Collimator Design Meetings

Minutes of the meeting 65 (21/04/2005)

The collimator design for two beams

- Preliminary specifications –

Front view

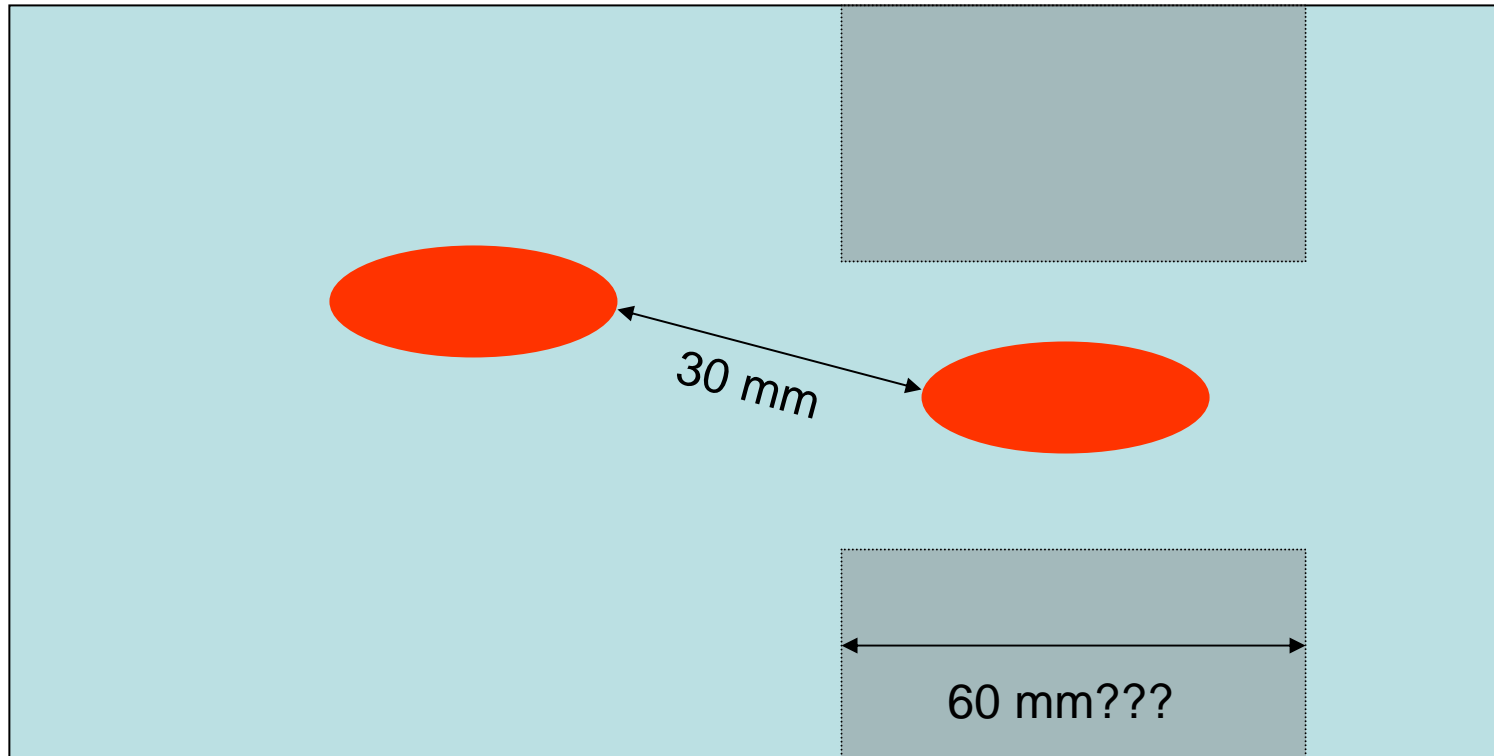
Check for impedance of the jaw edges → F. Ruggiero et al!

Degrees of freedom

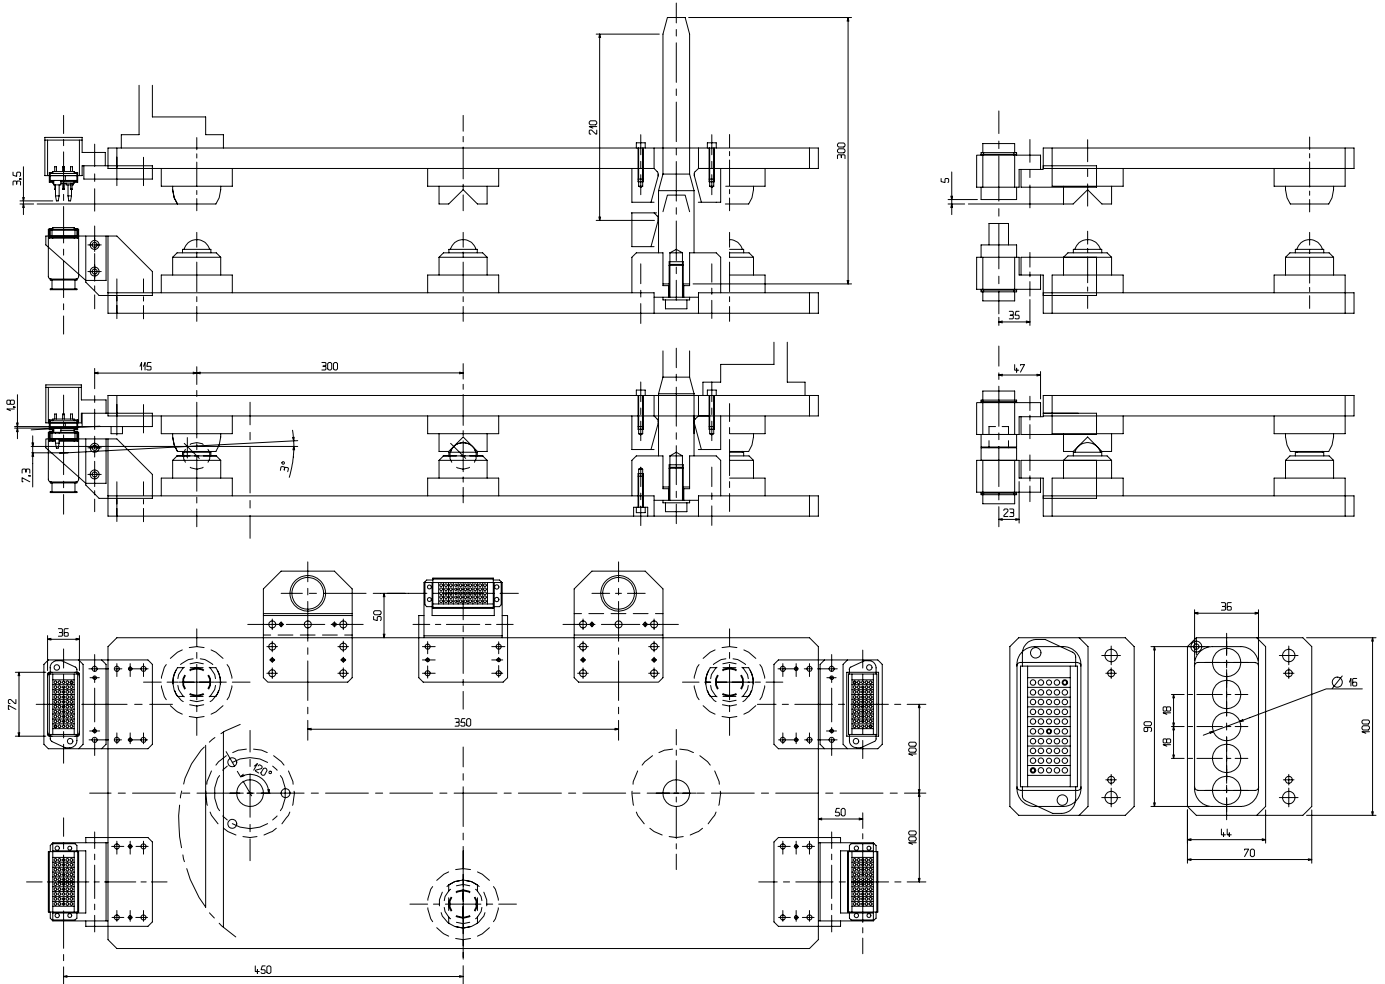
- Same as for TCP/TCS:
 - position at each end of jaw.
 - movement of whole tank to adjust edge of collimator with respect to outgoing beam!?

T0082331PL

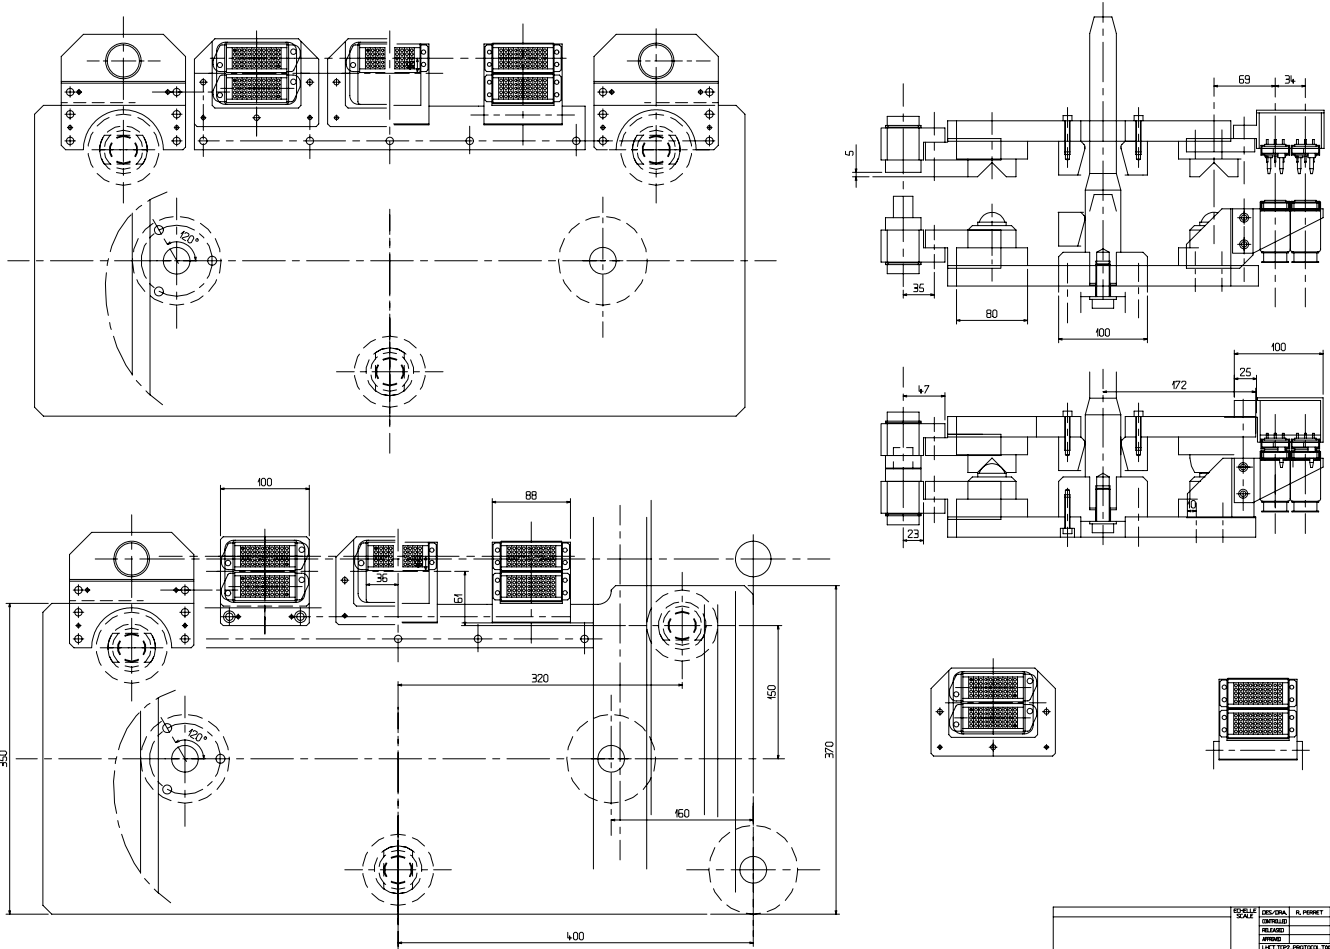
2. The positioning of the water and electric plug-ins is complicated by limited available space and by the slope and tilt of the tunnel. Several arrangements have been studied by Roger ([T0082323PL.pdf](#) [T0082331PL.pdf](#)), but a final solution has yet to be found!
